## ASSESSMENT REPORT

### Section 96(1A) Modification Oakdale South Industrial Estate (SSD 6917 MOD 3) Stage 1 DA Out of Hour Construction Works for Fill Importation

**Figure 9: Predicted Worst Case Noise Contours for Out of Hours Fill Importation Works**

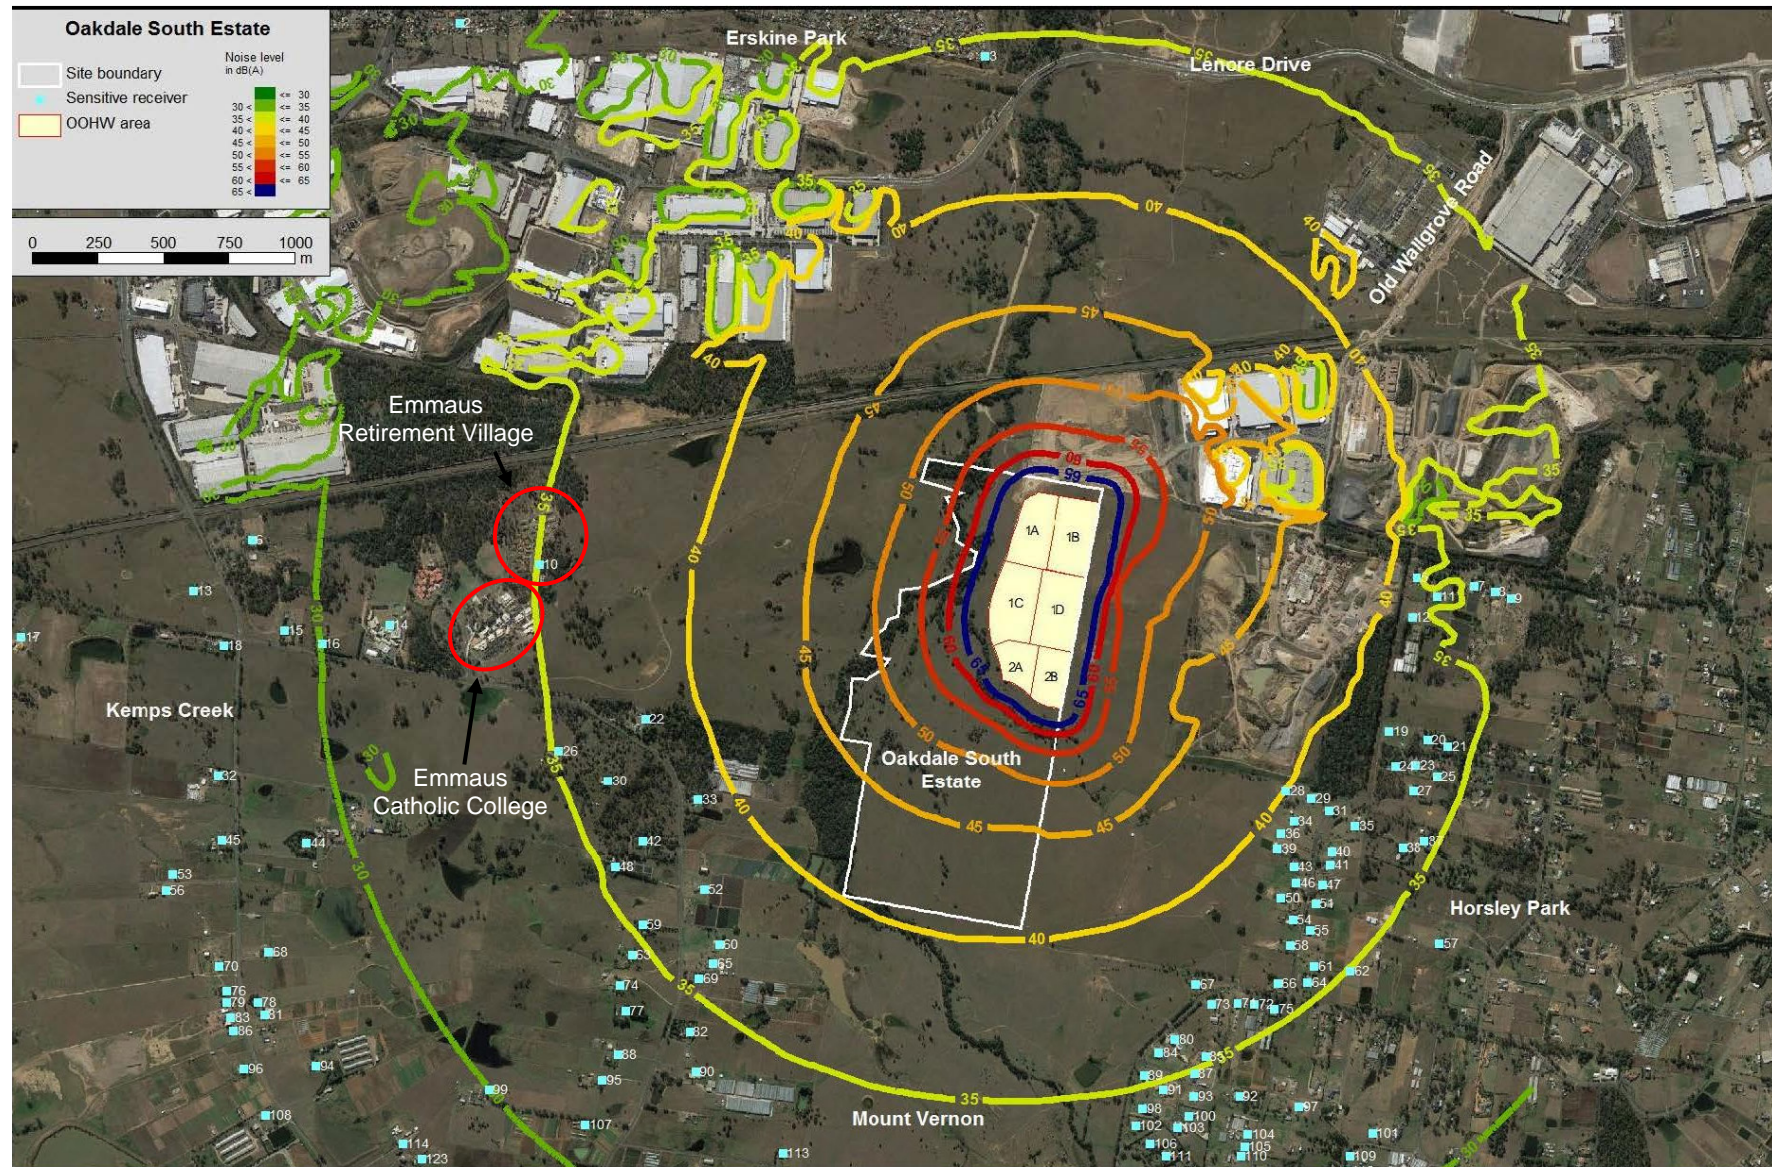
- works in zones 1A and 1B are not expected to exceed the NMLs at any receiver;
- works in zones 1C, 1D and 2A may exceed the NMLs by 1-2 dB and only works with a single bulldozer and compactor are recommended;
- individual receiver noise levels predict up to seven exceedances from work zone 2B where all equipment is used;
- noise levels at residences along Greenway Place are predicted to exceed the evening and night-time NMLs by 2-4 dB(A);
- where the use of a D10 bulldozer is excluded, two exceedances between 0-10 dB are predicted from zone 2B; and
- where two or more zones are proposed to operate with two bulldozers and two compactors, cumulative impacts of up to 9 dB are predicted. Where a single bulldozer is used in multiple work zones, exceedances are predicted up to 6 dB(A).

Work zone 2B is the closest zone to the nearest residential receiver and is the source of the highest number of NML exceedances. These exceedances are also the highest above the NMLs. Due to the number and magnitude of the exceedances, the Department considers the Applicant should not be allowed to undertake out of hours fill import activities in zone 2B to mitigate the potential noise impacts at the nearest residential receivers. Furthermore, as exceedances from cumulative works are predicted to be 6 to 9 dB(A) over the NMLs, the Department does not support out of hour works in more than one zone at any one time. Finally, the Department notes the Applicant does not intend to use a D10 bulldozer for out of hour works, however, as this piece of equipment was shown to cause exceedances in the NMLs from work zones 1D, 2A and 2B the Department considers a limit preventing its use is appropriate.

- adopt the NMLs assessed under the CNVIA for the out of hour works for fill importation;
- exclude out of hour works from being undertaken in work zone 2B;

**Figure 10: Construction Traffic Haul Routes**

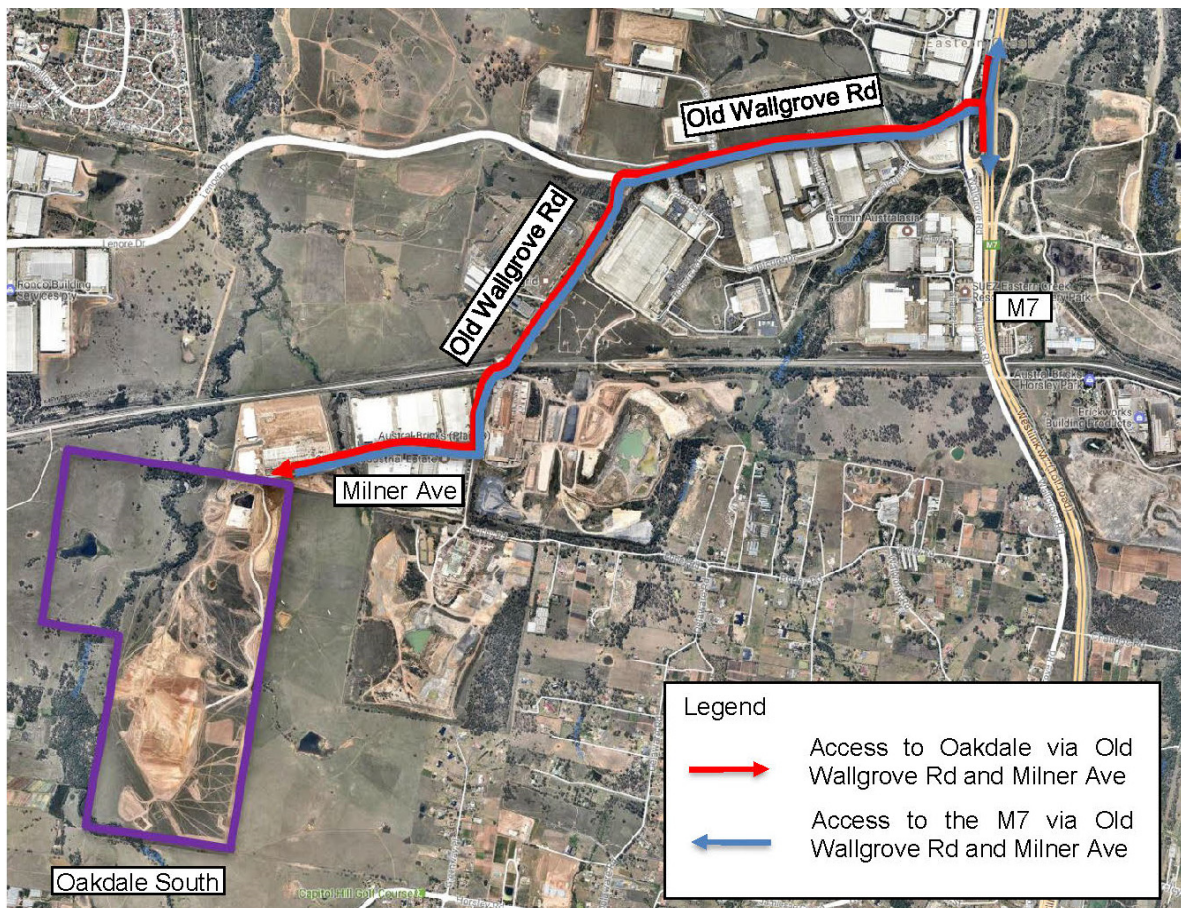
Council raised no concerns regarding construction traffic impacts. RMS raised concern that the proposed hours for the out of hour works (7 pm to 5 am) are close to the peak hours for the existing road network, and recommend the hours be revised to 8 pm to 4 am to maintain the efficiency of the road network.

The Department considers the potential construction traffic volumes are acceptable and would not result in any adverse traffic impacts on the regional road network for the proposed four-month period as the roads along the proposed haul route (see **Figure 10**) currently handle large volumes of traffic, with:

- limit out of hour works from 8 pm to 4 am as requested by RMS;
- ensure heavy vehicles only utilize the haul route depicted in **Figure 10**; and
- implement updated management measures, including:
  - limiting vehicle speeds, truck idling and the use of compression braking;
  - use of a run out or two stage approach when unloading material to avoid tailgates slamming into bins; and
  - limiting truck queueing.
